**CITY OF SNELLVILLE  
DEPARTMENT OF PLANNING & DEVELOPMENT  
MAYOR AND COUNCIL**

**CASE SUMMARY**

**CASE NUMBER:** #RZ 25-01

**DEVELOPMENT/PROJECT:** **65-Unit Single-family (Attached) Townhome  
Development**

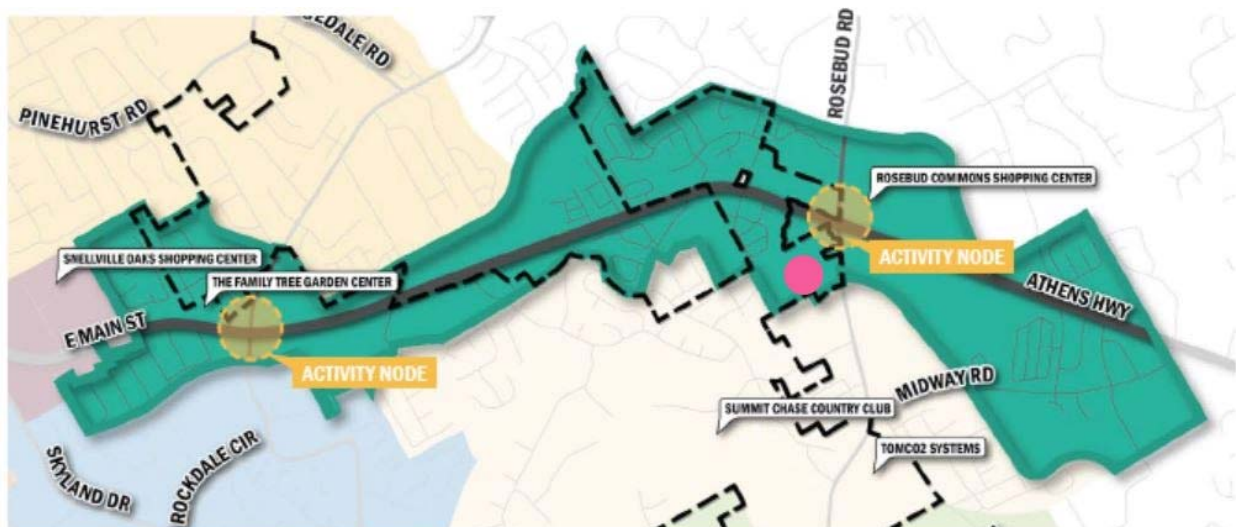
The conceptual rezoning site plan, dated 12-09-2024 (below) shows the general layout of the 65-unit townhome development with eleven (11) rear-entry townhome buildings and a single six-unit front-entry townhome building (Lots 14-19) with vehicular circulation provided by a 27-foot wide (back-of-curb) public/private road, 19-foot wide connectors and 16-foot wide one-way alleys.

Variance Analysis: The rezoning site plan shows what appears to be a 2.5-foot wide planter strip between the 5-foot wide sidewalk and street roll-back curbing (see Variance #2). Therefore, no variance is required except to reduce the 5-foot wide planter requirement to 2.5-feet (see Variance #3).

Variance Analysis: Because of the 24-foot narrow townhome width and 17-foot driveway width on Lots 14-19, roll-back curbing is appropriate due to the limited space between each driveway apron; therefore, making the transition between the driveway apron and vertical curbing difficult and ineffective.

Variance Analysis: For streets categorized as *Local Street –Residential (Urban)*, the minimum required roadway pavement width is 27-feet excluding concrete curb and gutter which typically measures 1.5-feet wide, per side. Combined, with the 27-foot pavement width and 3-feet of curb and gutter on both sides of the roadway, the code requirement is 30-feet, measured back-of-curb. This 3-feet of additional street width allows for a safer environment for the passage of two vehicles at points where there is on-street parking.

Recommendation: The Planning Department recommends *approval*.

Recommendation: The Planning Department recommends *denial*.

Variance Analysis: In consideration with the denial recommendation for the reduced street width in Variance #3 above, the 2.5-foot planter width reduction is consistent with other townhome developments in the city and still allows the planting of understory street trees with a reduced canopy width in the planting area between the townhome buildings and sidewalk.

Recommendation: The Planning Department recommends *approval*.
